UNITED STATES PATENT AND TRADEMARK OFFICE

APPLICATION NO.	FILING DATE	FIRST NAMED INVENTOR	ATTORNEY DOCKET NO.	CONFIRMATION NO.
10/662,870	09/15/2003	Neal Tate Saiki		2145

Office Action Summary

DETAILED ACTION

FIG. 6

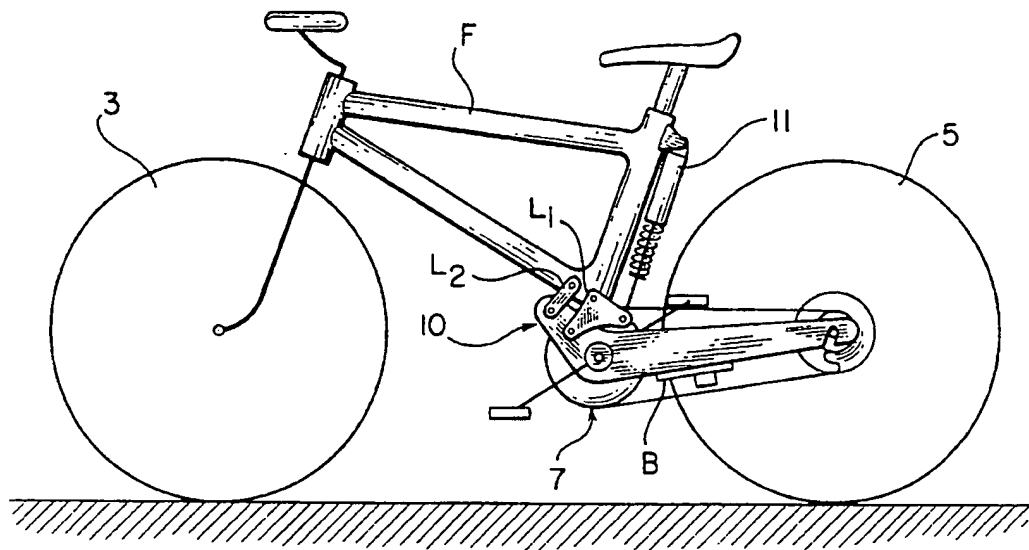
Claims 1-10 are rejected under 35 U.S.C. 102(b) as being anticipated by Harris (USPN. 5,452,910).

Harris discloses all of the structural of a rear suspension for a bicycle, the suspension comprising:

- a) a main frame (F),
- b) a shock absorbing means (11),
- c) a swingarm (SW) that moves relative to the main frame,
- d) a bicycle rear wheel attached to said swingarm,
- e) a crank assembly (figure 7) attached to said swingarm, and
- f) a linkage means (L1 and L2) for connecting said swingarm to said frame,
- g) said swingarm has an instant center of rotation that moves as the swingarm moves from the uncompressed to fully compressed state, the instant center of rotation is horizontally located forward of the crank assembly center when the swingarm is uncompressed and moves significantly rearward as the suspension is compressed, thus, thus reducing in the vertical movement of said crank assembly as the swingarm is moved from the uncompressed to compressed position (see attachment).
